PROJECT:
RONDELL OASIS HOTEL

DRAWING TITLE:
SITE PLAN

PROJECT:
RONDELL OASIS HOTEL RESTAURANT & BAR
26300 RONDELL STREET
CALABASAS, CA

ISSUE: Preliminary review #1a
DATE: February 14, 2018

PARTIAL FLOOR PLAN - FOOD SERVICE EQUIPMENT - RESTAURANT & BAR

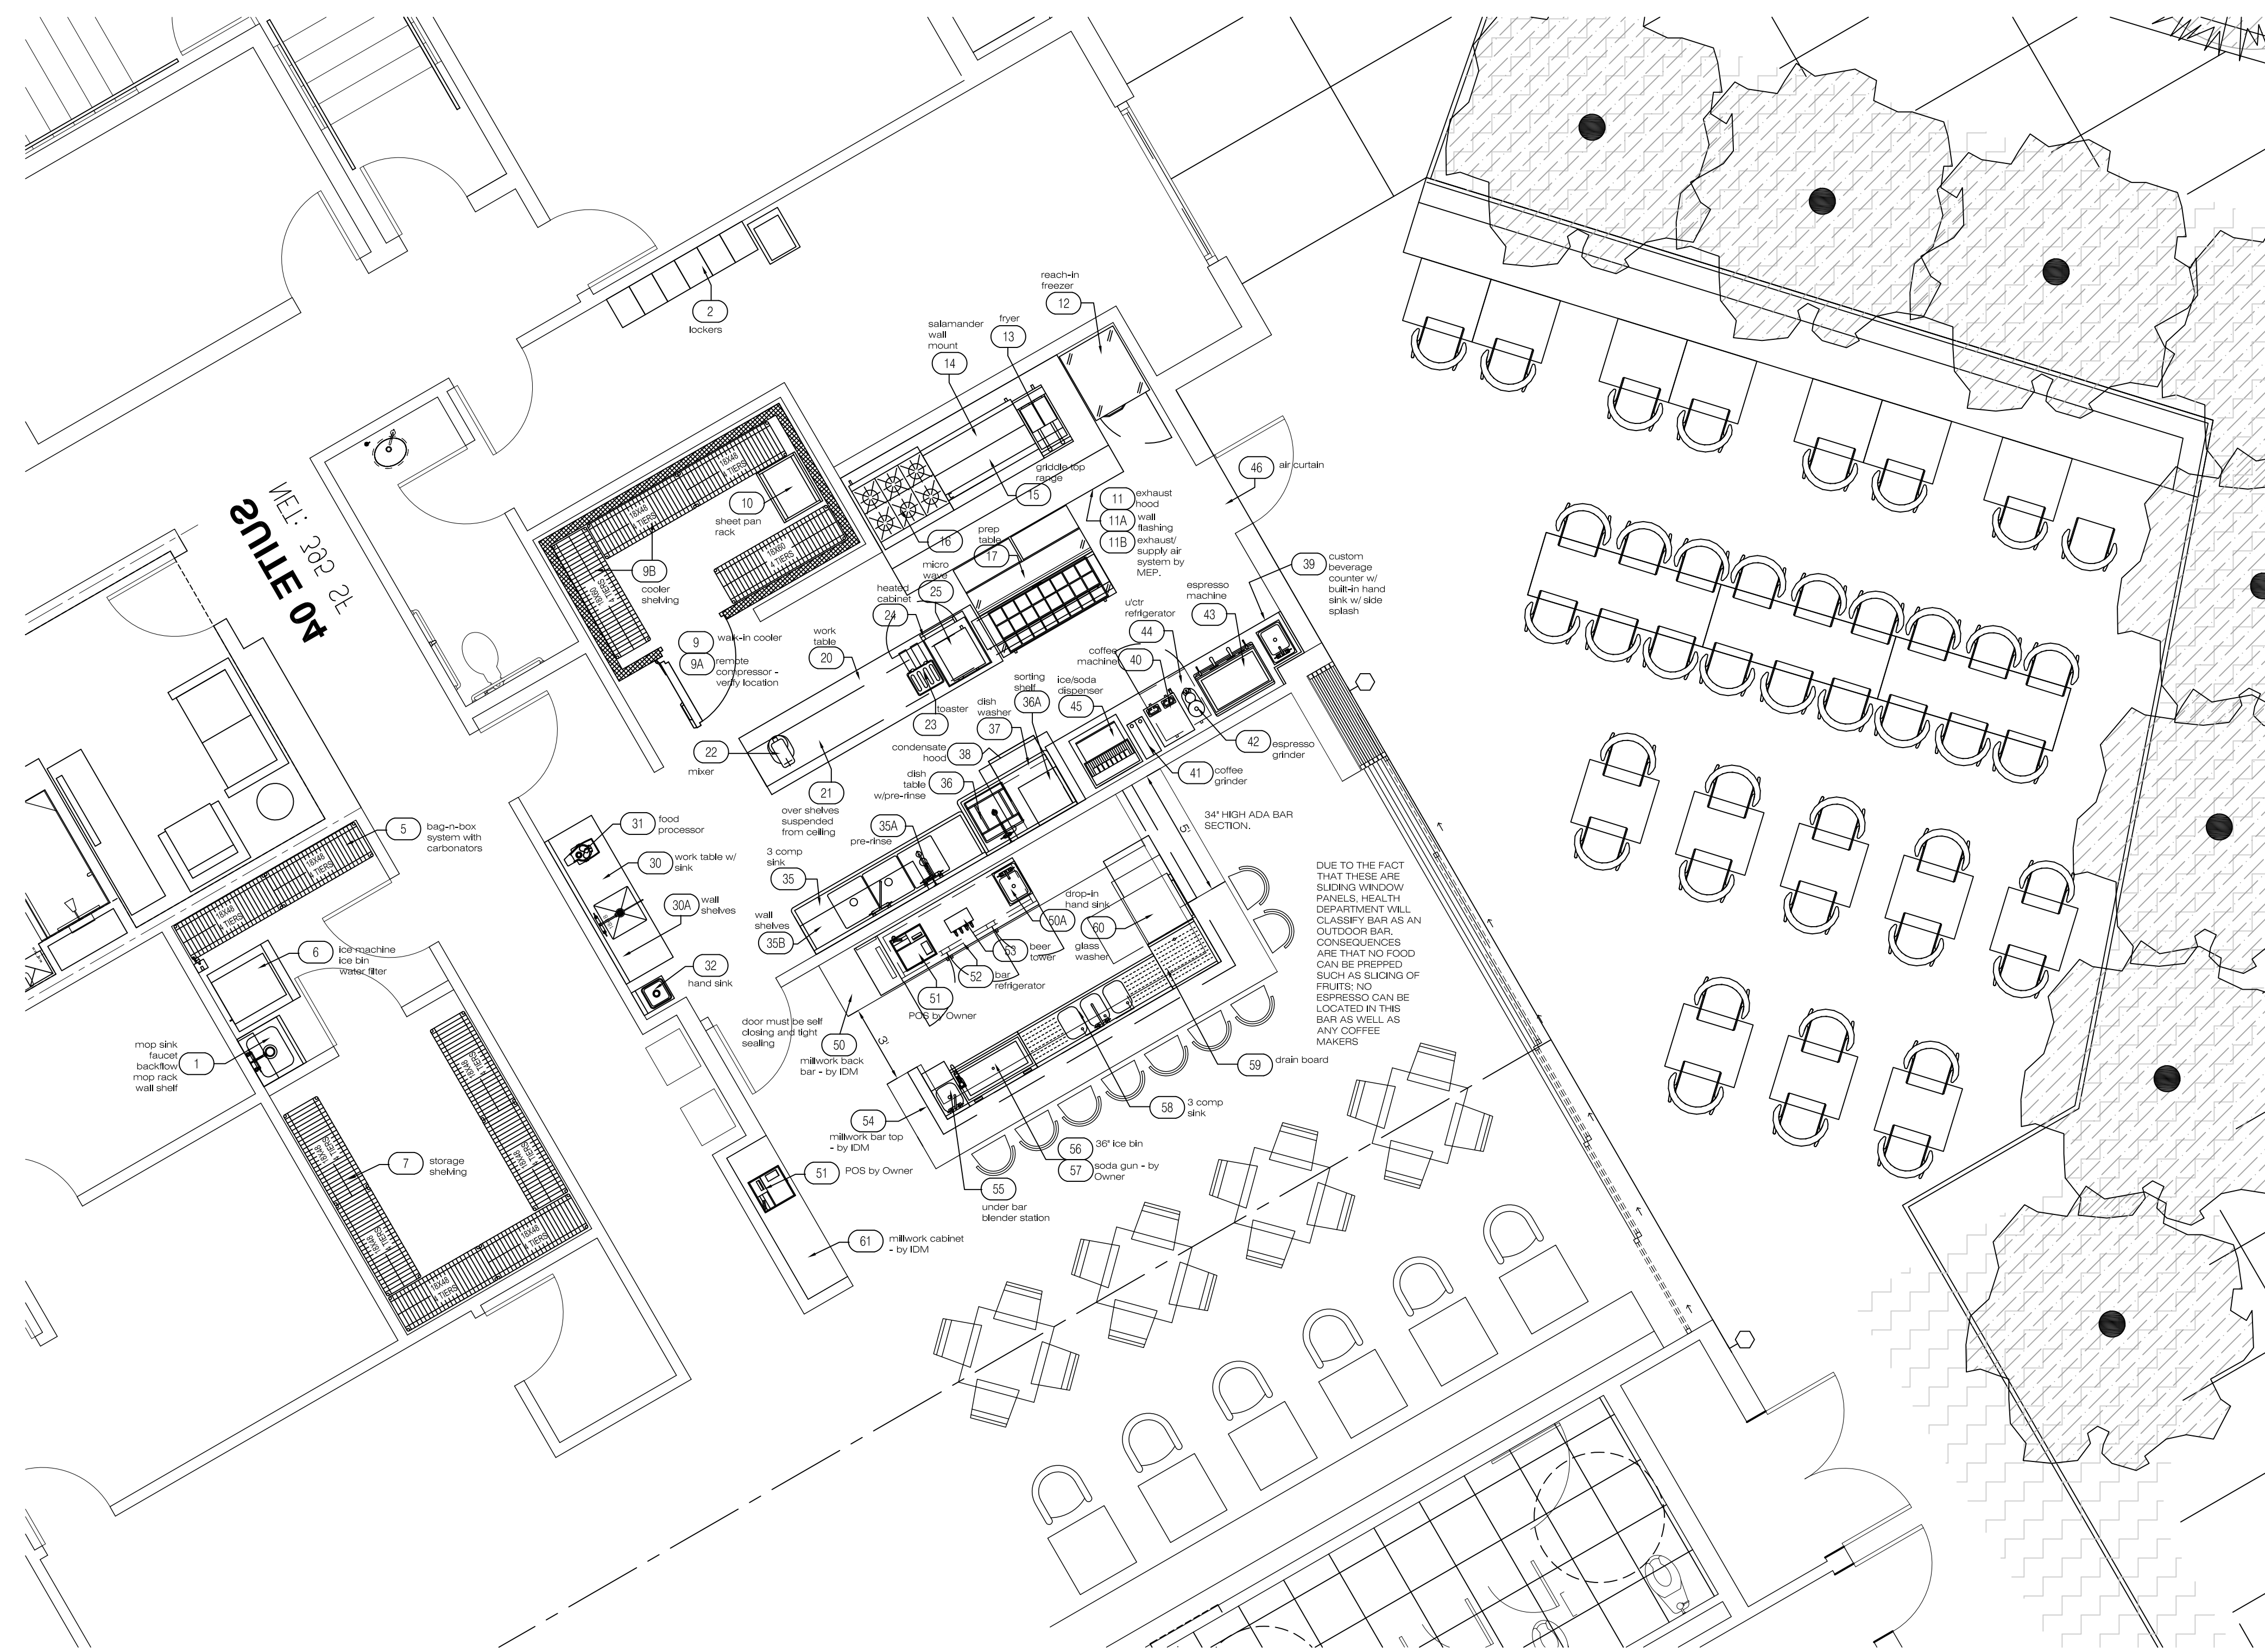
In order to accommodate equipment as specified by others, interior walls have to be adjusted in order to provide a functional kitchen.

Specifications called for upright dish washer which cannot be accommodated due to spatial constraints. Undercounter high temp dish washer is shown instead. A condensate hood will have to be located above the undercounter high temp dish washer to comply with local building and health dept codes.

Mop sink: unless there is a mop sink/janitorial closet located within 100 feet, mop sink will have to be located in employee break room.

Bar:
Moved wall between wall and kitchen approximately 15" into lounge area in order to provide required aisle clearance in kitchen.

As noted, due to the fact that there are sliding window panels, health department considers this to be an outdoor bar and therefore must meet all the requirements.

Requirements include the following:
no prep can take place which would include the slicing of fruits and the making of espresso and coffee. These activities will have to be done in the kitchen.

Door leading into the kitchen must be self-closing and tight fitting.

Have indicated 60" ADA counter section at bar to comply with ADA accessibility requirements.

Did not specify a high temp glasswasher as local codes require a condensate hood over any high temp dish washer, high or low temp.
